**COMMONWEALTH OF KENTUCKY
BEFORE THE PUBLIC SERVICE COMMISSION**

**ELECTRONIC 2024 INTEGRATED RESOURCE
PLAN OF DUKE ENERGY KENTUCKY, INC.**

)
)
)
) **Case No. 2024-00197**
)
)
)
)

**SIERRA CLUB’S COMMENTS REGARDING DUKE ENERGY
KENTUCKY, INC.’S 2024 INTEGRATED RESOURCE PLAN**

Figure 3: Commitment Status for East Bend Unit 2

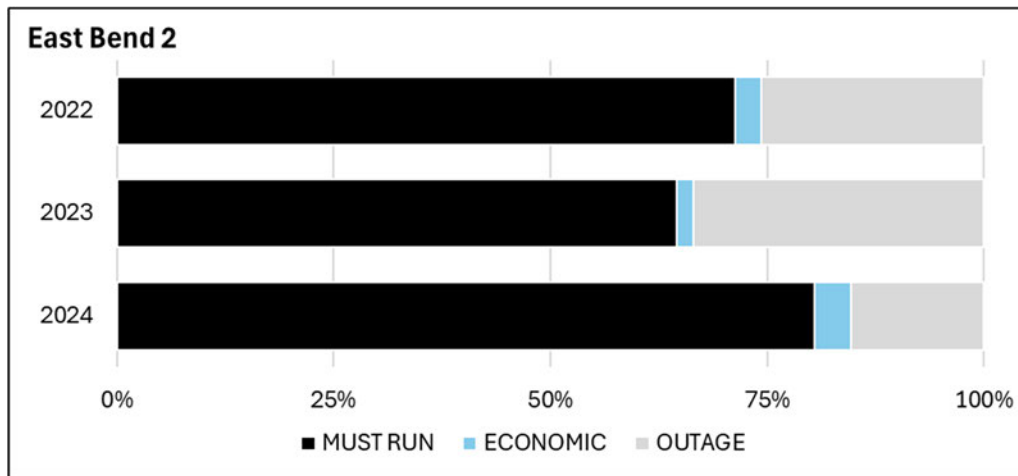
Instead of offering the unit for economic commitment from PJM, Duke has elected to submit East Bend to PJM as “must run” in nearly every hour it is not on an outage.³⁸ Figure 3 shows that in 2022, East Bend was committed as must-run 96 percent of the time when not on an outage.³⁹ In 2023, East Bend was committed as must-run 97 percent of the time when not on an outage.⁴⁰ Similarly, thus far in 2024, the unit was committed as must-run 95 percent of the time when not in an outage. While electing East Bend to be committed as must-run, Duke is forcing the unit to operate even in hours where its variable costs fall below the market price offered by

PJM, which leads to Duke losing additional money for operating an [REDACTED] unit. On the contrary, if a unit is only committed economically, and the owner bids its true variable costs, then it would never lose money (on an energy basis) over the course of a year. The Company may prefer to have hands-on control over its unit’s operations, but by doing this it is also exposing itself and ratepayers to market losses.
